SUBMISSION

a written submission by way of objection

BILL TULLOCH BSC [ARCH] BARCH [HONS1] UNSW RIBA Assoc RAIA
Director
DA Objection Pty Ltd

RE: **SSD-76220734**
156 OCEAN STREET, NARRABEEN NSW 2101
INDIGO BY MORAN
SENIORS HOUSING
WRITTEN SUBMISSION: LETTER OF OBJECTION
SUBMISSION: TULLOCH

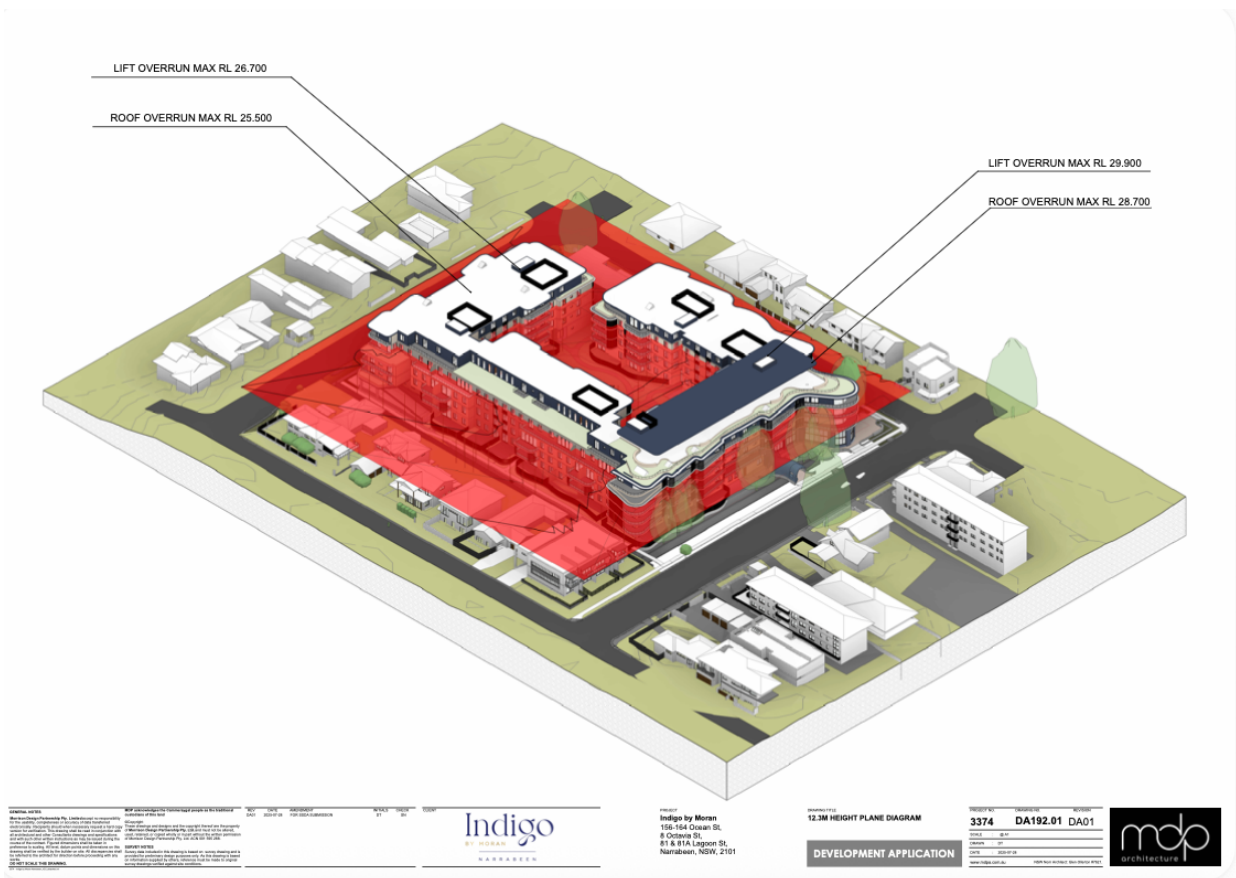
150 - 152 OCEAN STREET NARRABEEN has not been adequately assessed by the Applicant.

My clients north facing living, dining, kitchen and bedroom windows, face the subject site. These windows have existing Winter Solstice solar access removed by the proposed non-compliant development.

The main living, dining, kitchen windows receive less than one hour in the early morning, and less than one hour in the late afternoon.

The proposal has not setback the balconies to the full 6m and 9m SEPP controls, that face these windows.

The above diagram shows the massive non-compliances within the proposal. The proposed building height of 21.1m represents an 8.8m or 71% departure from the Development Standard with Bonus [8.5m + 3.8m], and this massive non-compliance causes the proposed development to be inconsistent with all SEPP, LEP & DCP standards and controls, and fails all objectives. The proposed SIX STOREY MASSIVE DEVELOPMENT adjacent 8.5m HOB zones with predominantly ONE to TWO STOREYS is plainly unacceptable.

I ask that the Height Blanket be checked, so that the base levels accord with the Registered Surveyors Drawing.

Unless the Applicant submits Amended Plans to resolve all of the adverse amenity impacts raised within this Submission, I ask The Department to REFUSE this SSDA.

Figure 25 Interface with Surrounding Sites

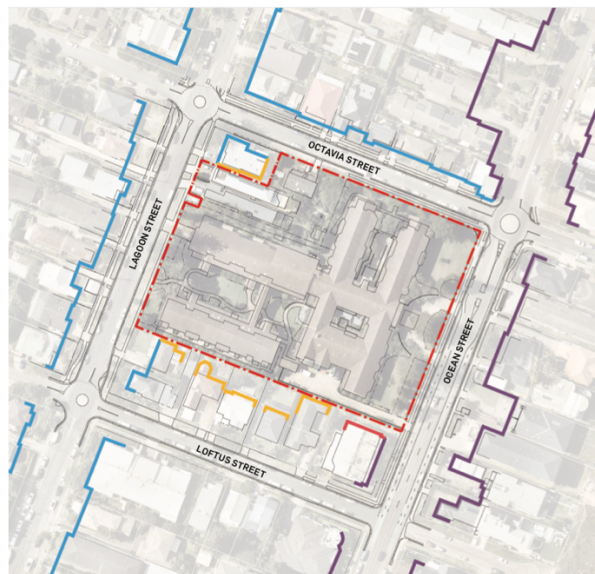
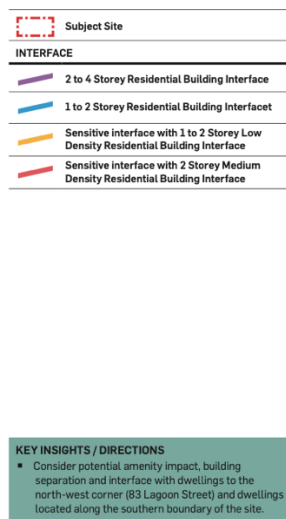
The built form should respect the built form interface, and present similar two/three storey development facing Loftus Street dwellings, Octavia Street and Lagoon Streets.
